# Airworthiness Directive of The Netherlands

**BLA nr. 1993-040/4**

**Ball and Socket Connectors**

**EQUIPMENT & FURNISHINGS - BALL & SWIVEL JOINT LOCK PLATES - INSPECTION/MODIFICATION**

**L'Hotellier ball and socket connectors with lock plate**

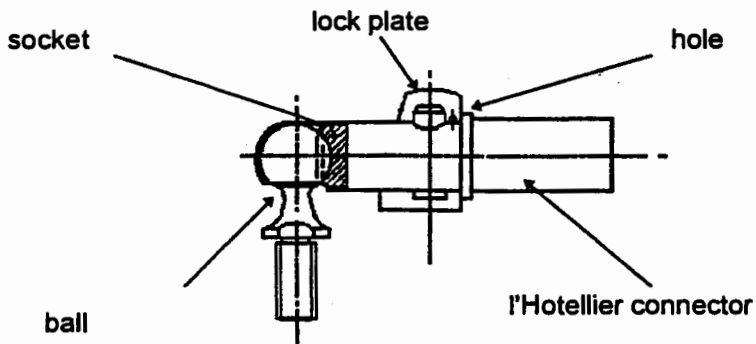
If the connectors are not yet equipped with safety pins (e.g. I'H 140-31 made by Hotellier), these safety pins have to be retrofitted. In certain cases it may become necessary to rebores the hole in the lock plate, which is provided for visual inspection, to  $\varnothing 1.2$  mm so that the safety pin can be inserted.

fig. 2

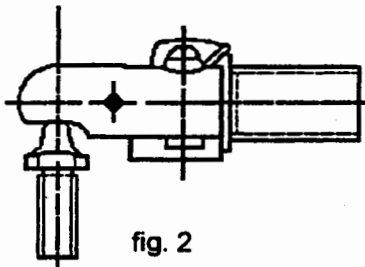
The following systems to secure l'Hotellier ball and socket connectors are LBA-approved: Uerlings sleeves or Uerlings type sleeves (see section III), safety pin (figures 2 and 2a), LS-safety sleeve (figure 3), Schempp-Hirth spring (figure 4) und Wedekind locking system (figure 5).

#### L'Hotellier ball and socket connectors

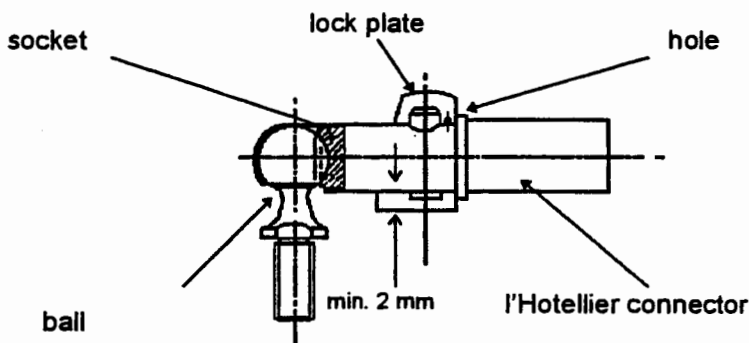
The socket is to be slid completely over the ball with the lock plate pressed down. During locking the lock plate moves back slightly so that in a correct connection the hole on the narrow edge of the lock plate becomes visible.

The safety pin is to be inserted in this hole thus securing the ball and socket connector.

By loading the connection full engagement of the ball is to be verified!

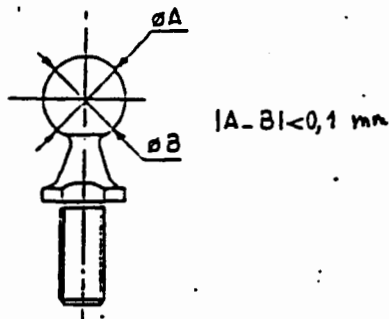
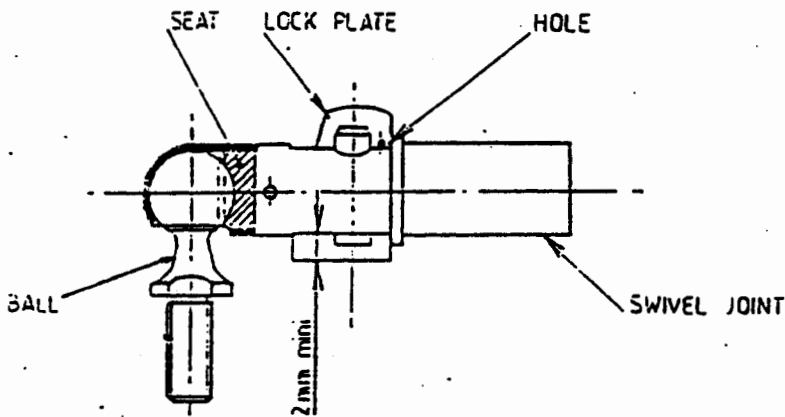
### 2.2. BALL SPHERICITY MEASUREMENT (See fig. 2)

The variation between several measures of the ball diameter must not exceed 0,1 mm.

### 2.5. MEASUREMENT OF THE LOCKER LOWER PART PROJECTION AFTER ASSEMBLY OF THE SWIVEL ON THE BALL (see fig. 1)

This projection must be higher than 2 mm.
